STAFF REPORT

SUBJECT: FP-2021-0028
Cache Creek Final Plat

Final plat consisting of 41 buildable lots and 4 common lots on 13.99 of land in the R-4 zoning district, developing in a single phase.

B. Final Plat (date: 4/29/2021)

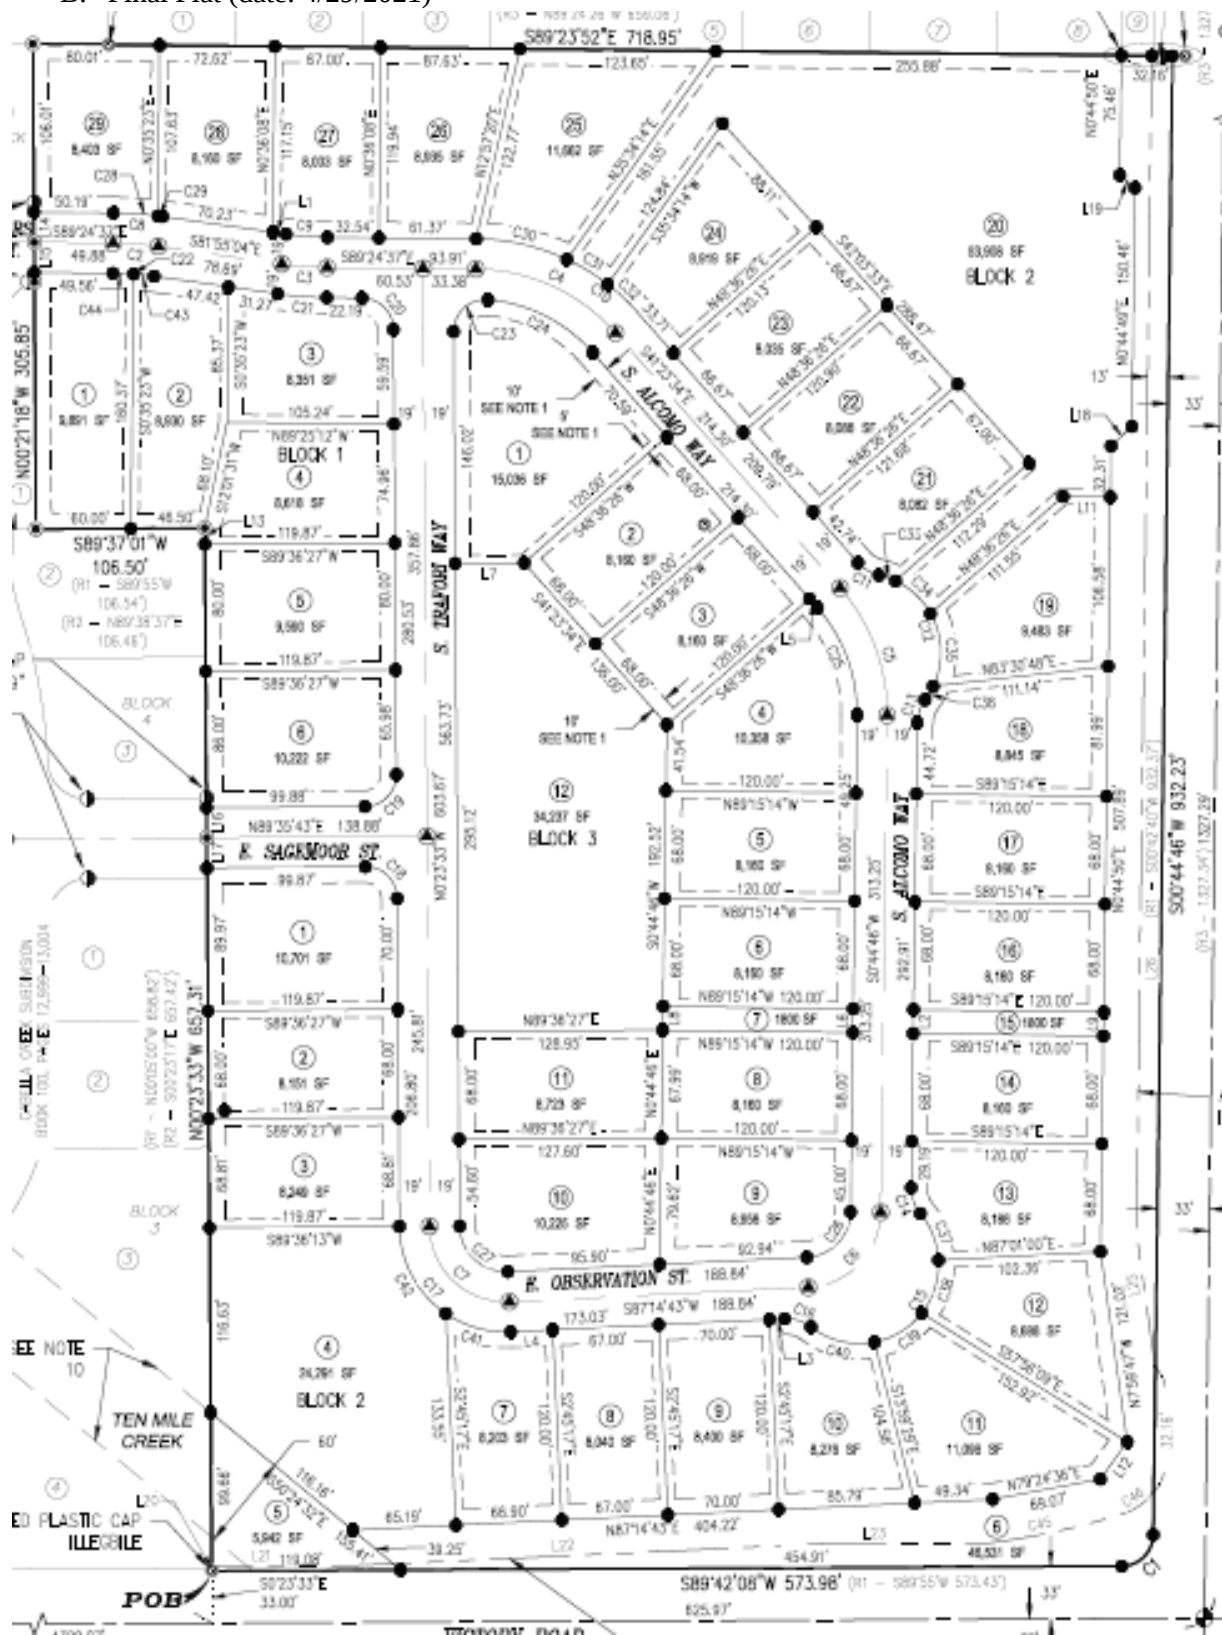
The existing accessory buildings shown in Lot 20, Block 2 do not appear to meet the minimum 15' rear setbacks as required in the R-4 zone district. The applicant understands as a condition of approval, the plat must be adjusted to ensure the structures maintain the proper setback or the structures shall be removed.

6. Prior to City Engineer signature on the final plat, the final plat prepared NV5, stamped by Robert Gromatzky, dated: 04/29/2021, included in Section V.B shall be revised as follows:

- a. Note 8, add Instrument Number.
 - b. Note 9, add Instrument Number.
7. The landscape plan prepared by Breckon Landscaping on February 10, 2021 is approved as submitted.

5. Prior to signature on the final plat, the applicant shall relocate all existing structures in Lot 20, Block 2 to meet the required setbacks for the R-4 Zone or shall remove the structures.
